AGENDA

January 19, 2017 Standards Committee Meeting

RE: Agenda for the January 19, 2017 Standards Committee Meeting

REVISION TO STANDARD SPECIFICATIONS AND STANDARD DRAWINGS
 802-SNGS-13 STEEL SIGN POSTS (WITH MARKUPS)

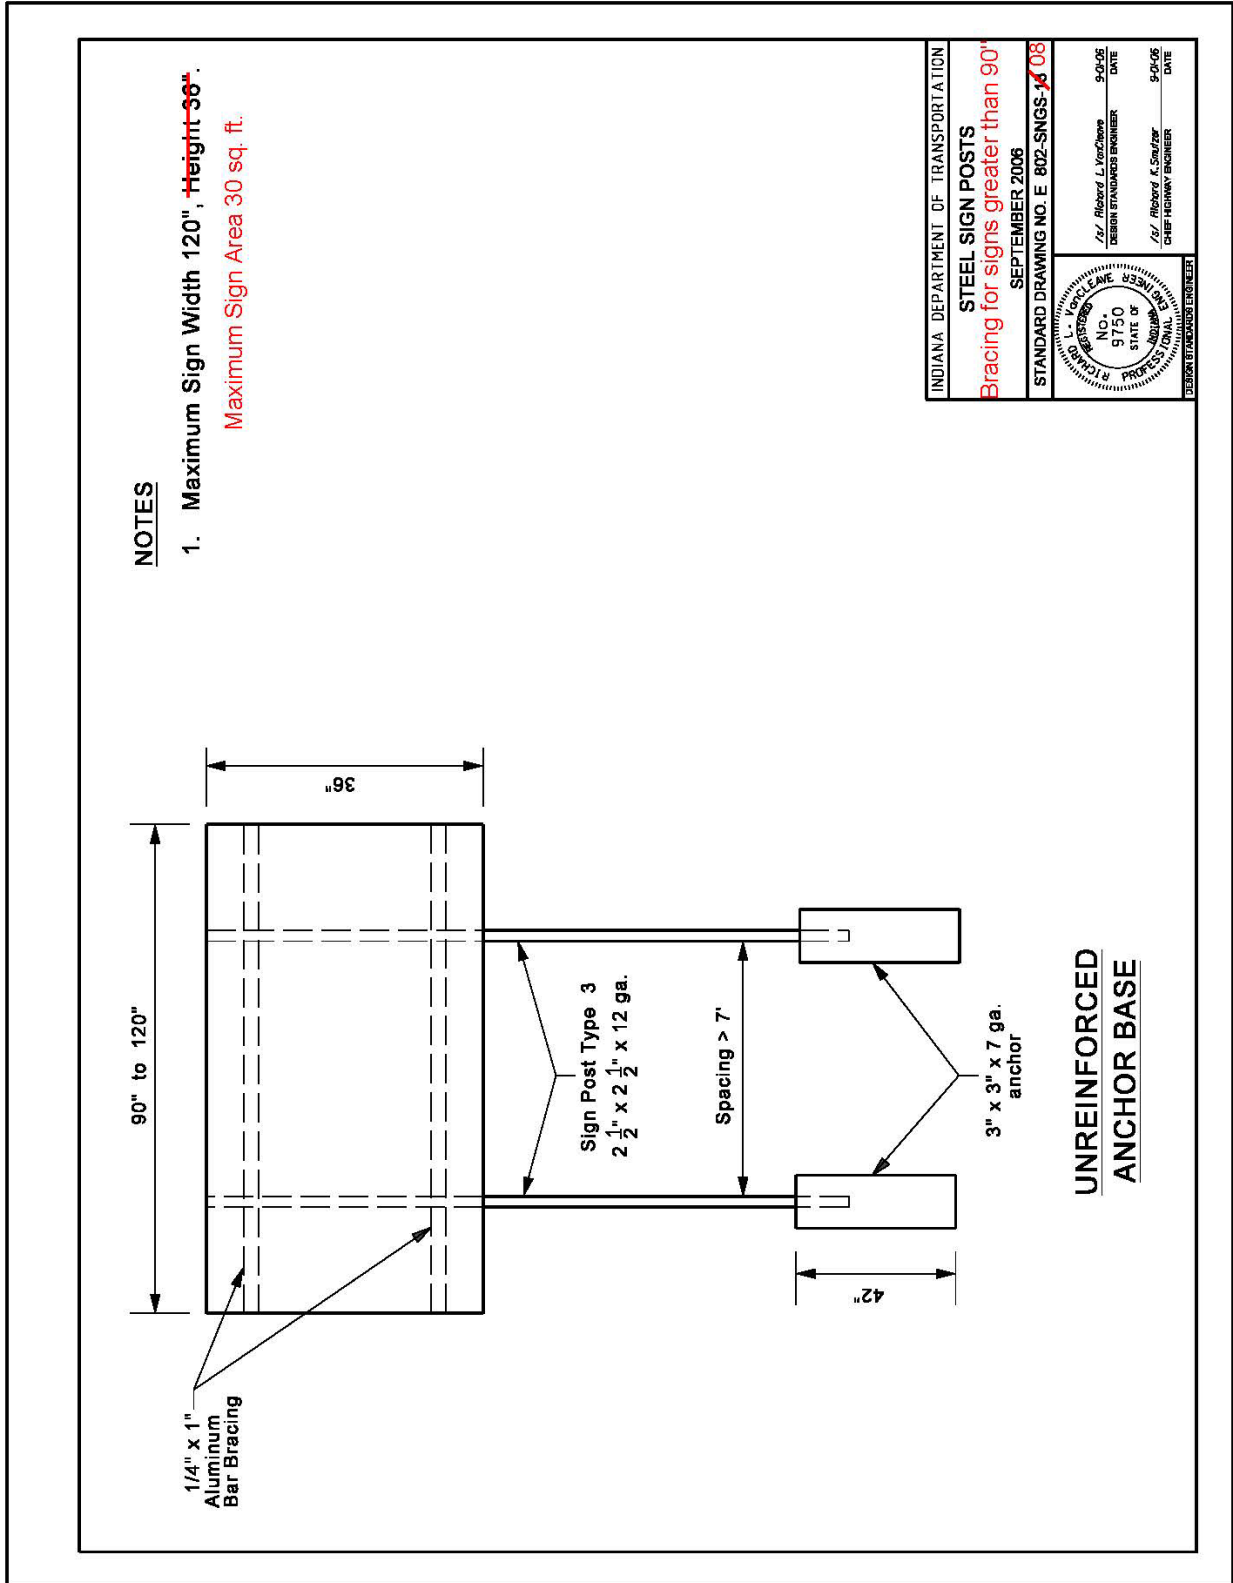
Table will be moved to 802-SNGP

807-LTHI-05 HIGHWAY ILLUMINATION TOWER DETAILS BOTTOM LATCH (WITH MARKUPS)

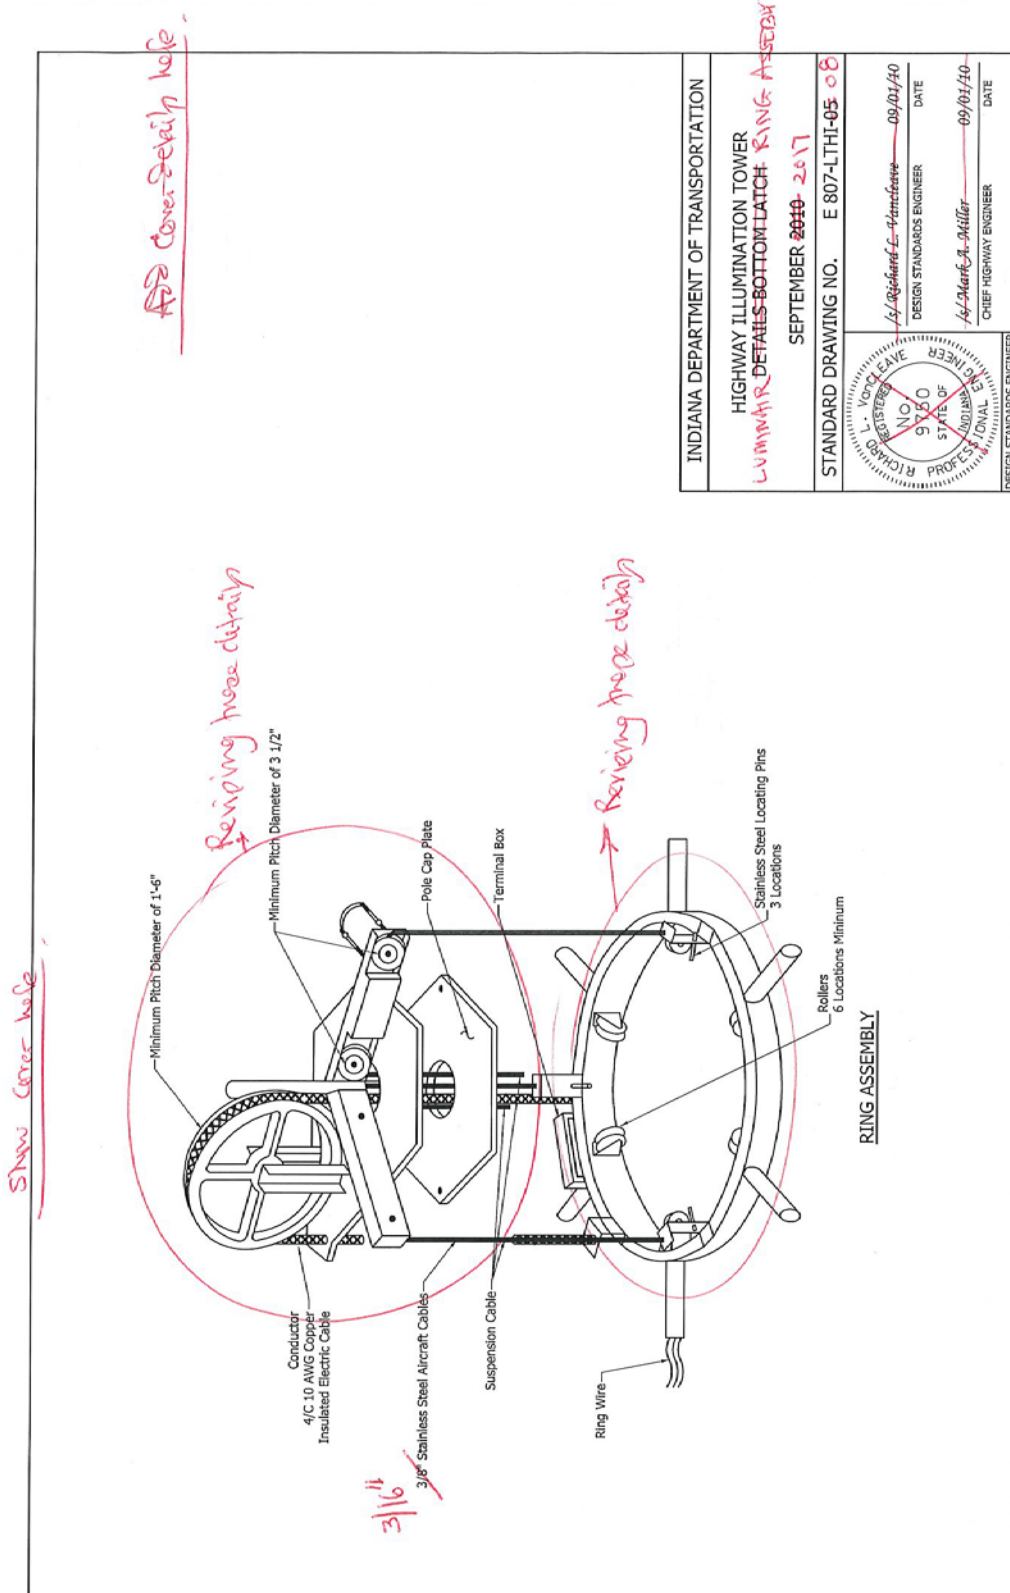
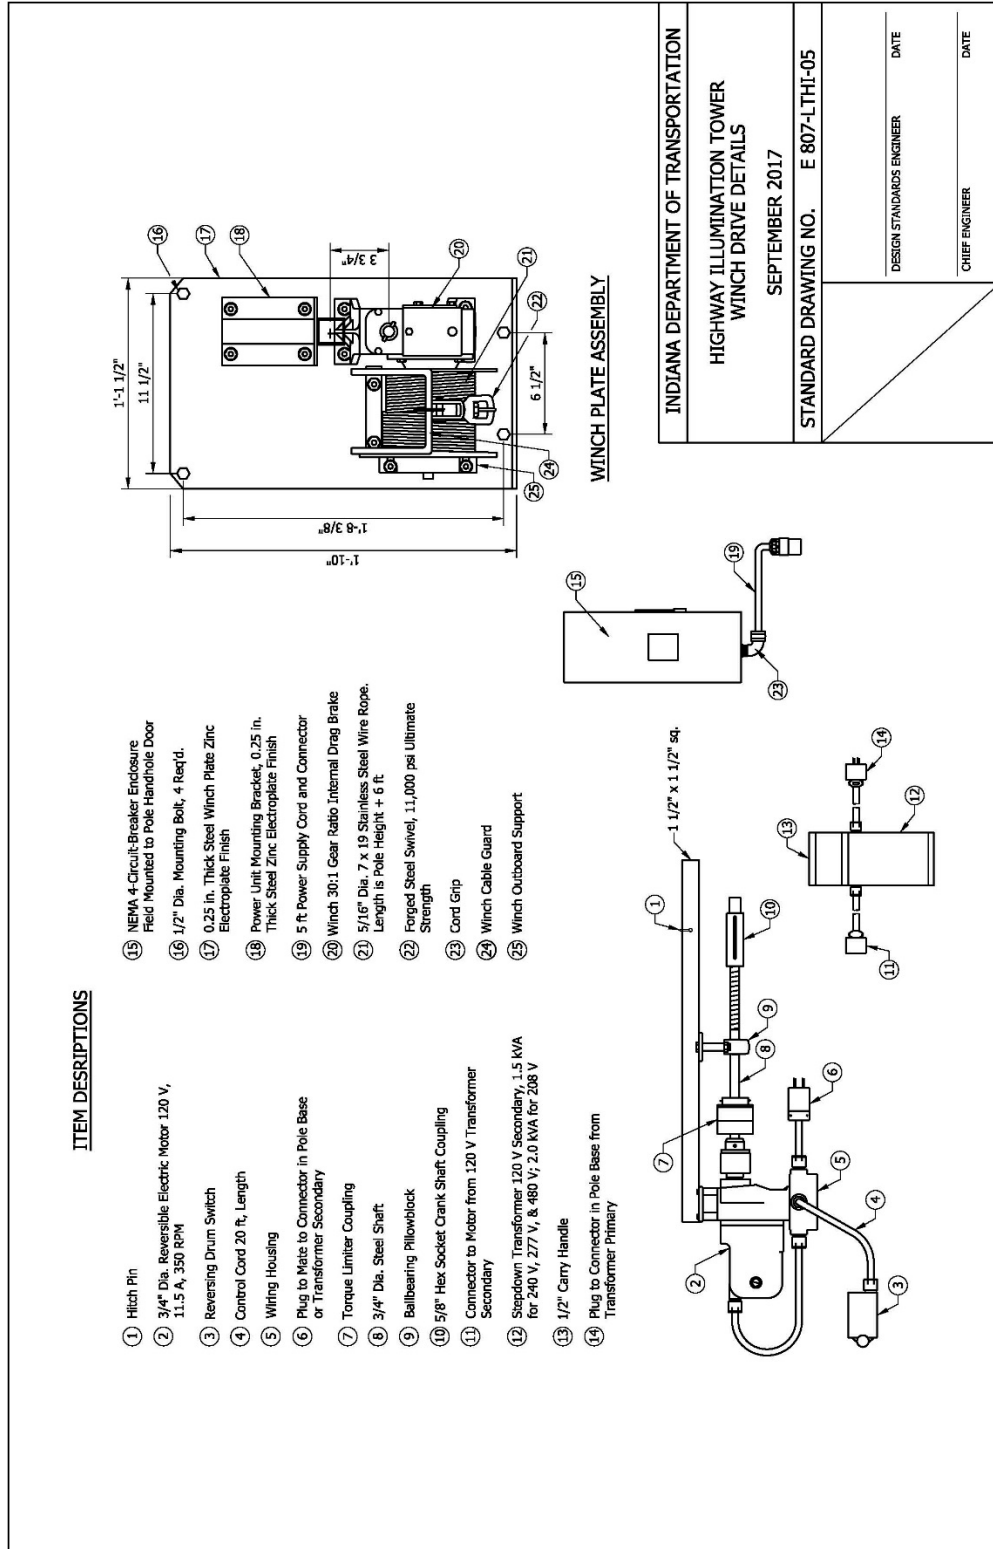
PROBLEM(S) ENCOUNTERED: The diameter (3/8") of the suspension cables for high mast tower's ring assembly shown in the current standard drawing 807-LTHI-05 is not correct per industry standards. Details of the head frame assembly are outdated. Additionally the minimum breaking strength of the suspension cables indicated in the Standard Specification is incorrect.

807-LTHI-06 TEMPORARY HIGHWAY ILLUMINATION DETAILS (WITH MARKUPS)

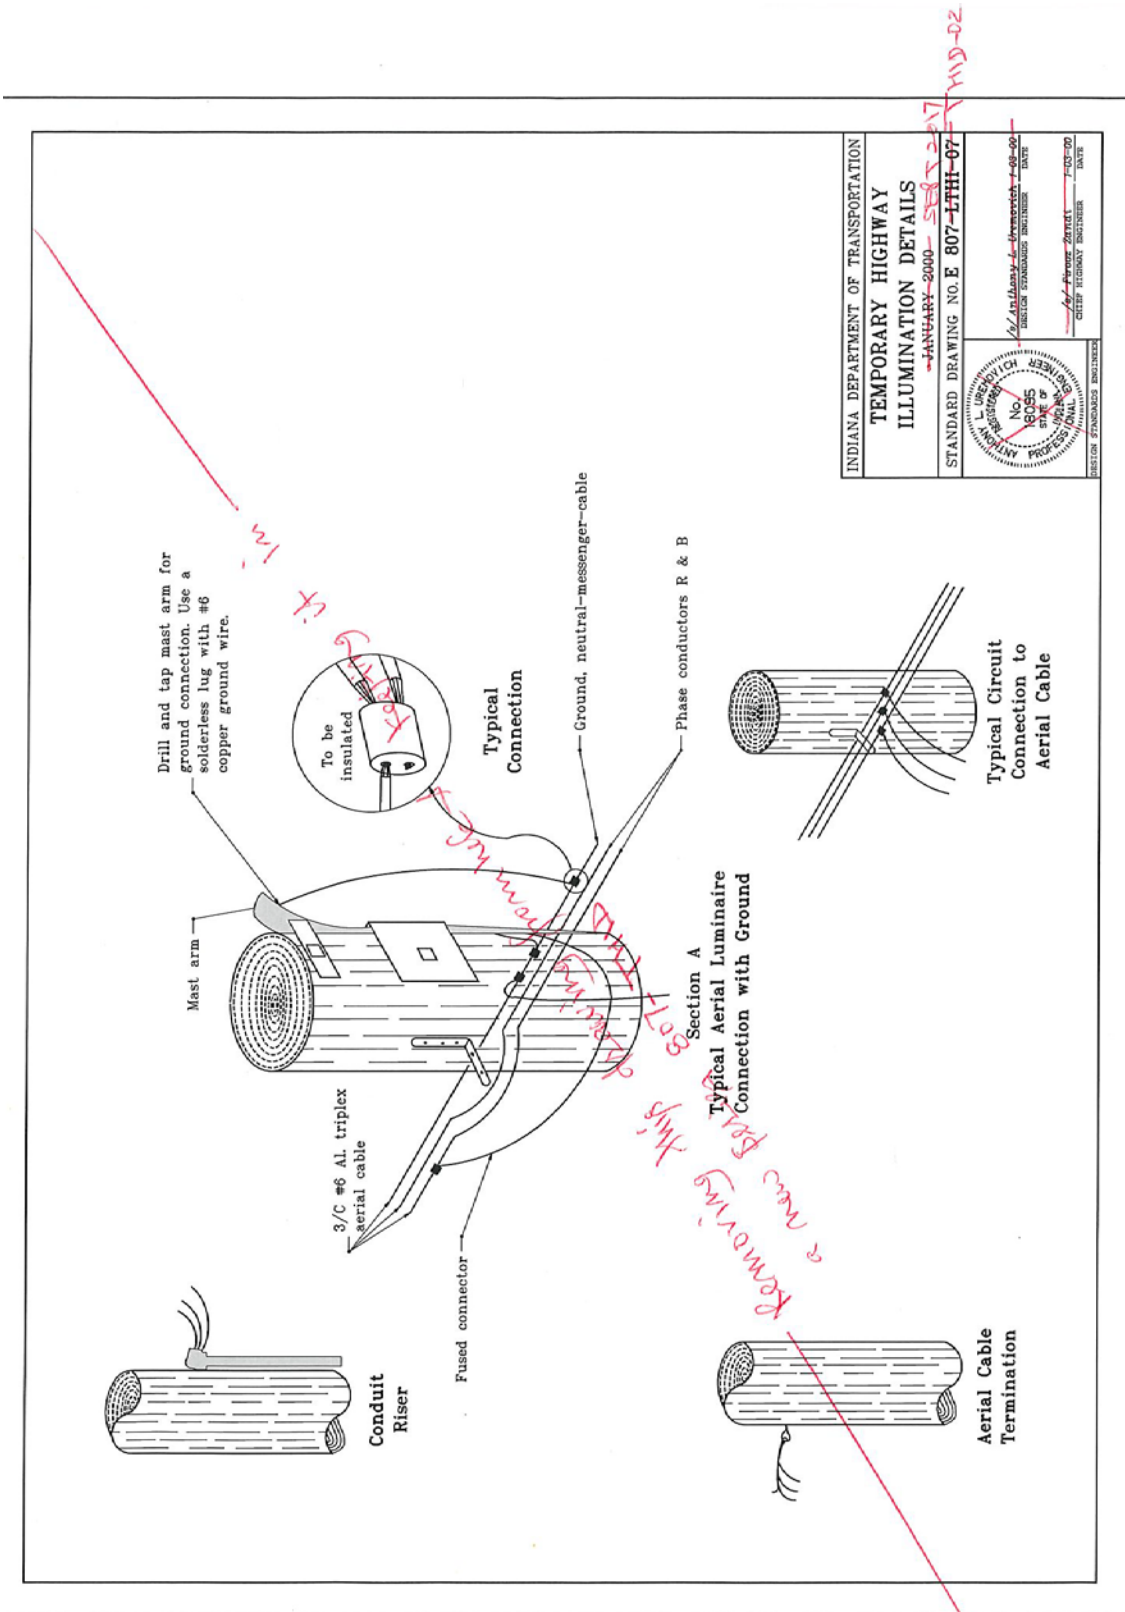
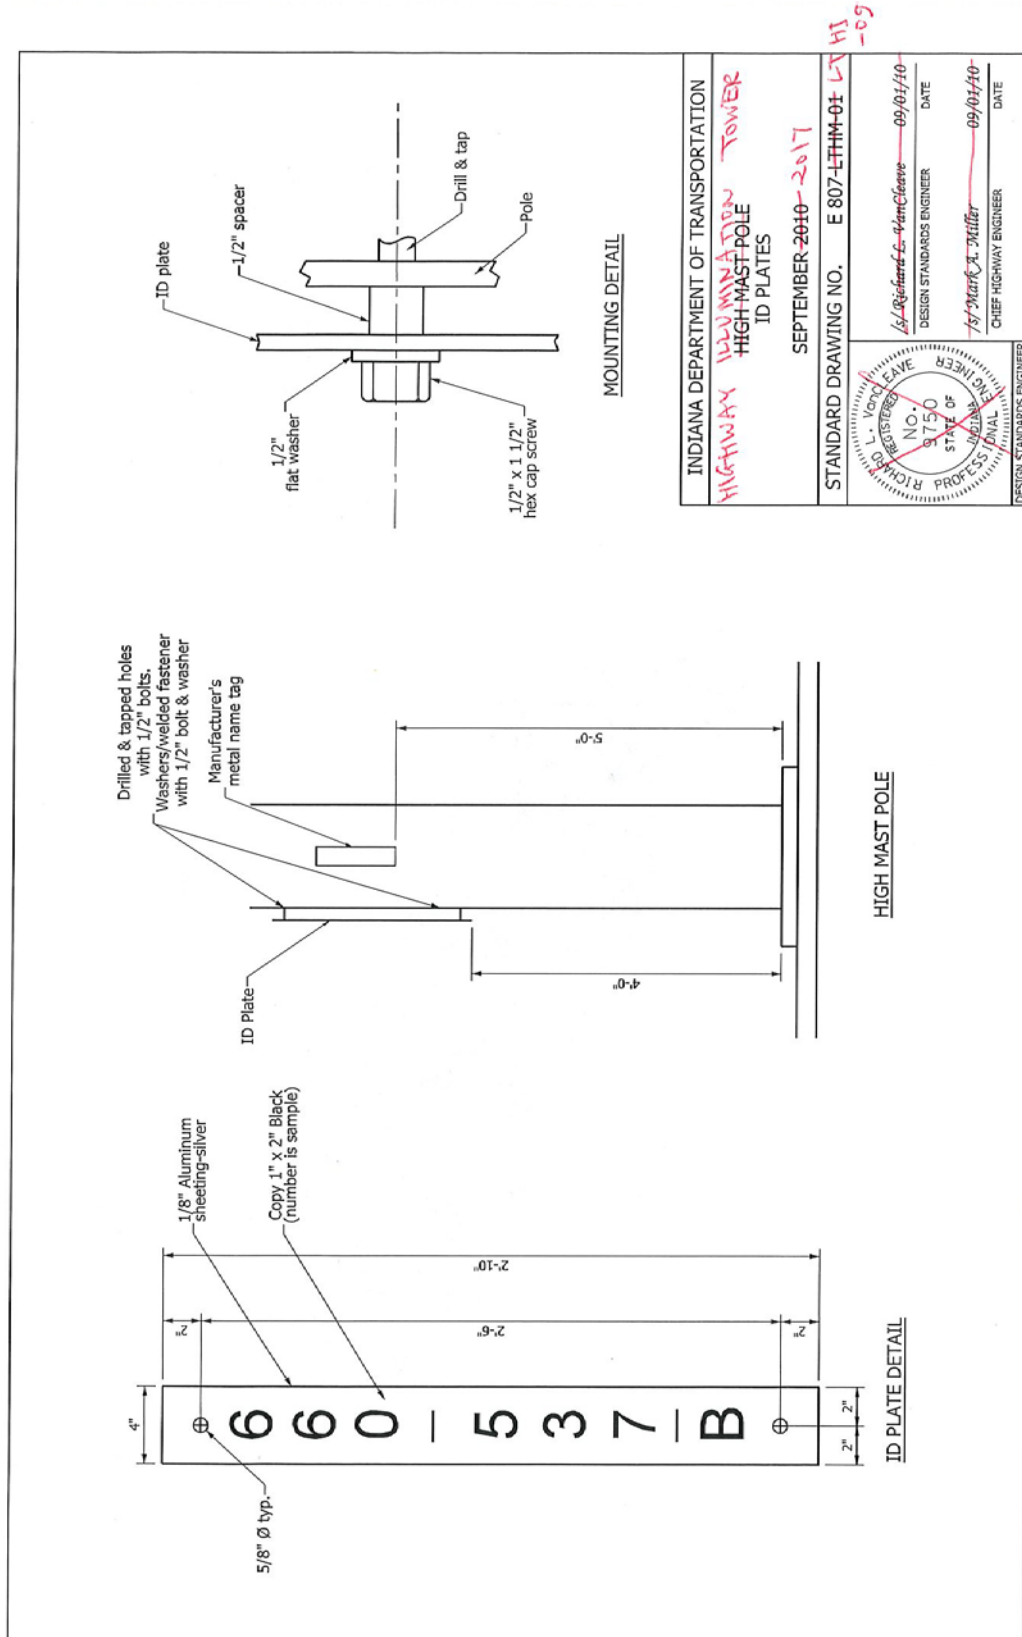
Move standard drawing 807-LTHI-06 and 07 for temporary highway illumination details from 807-LTHI series to a new series- 807-THID.
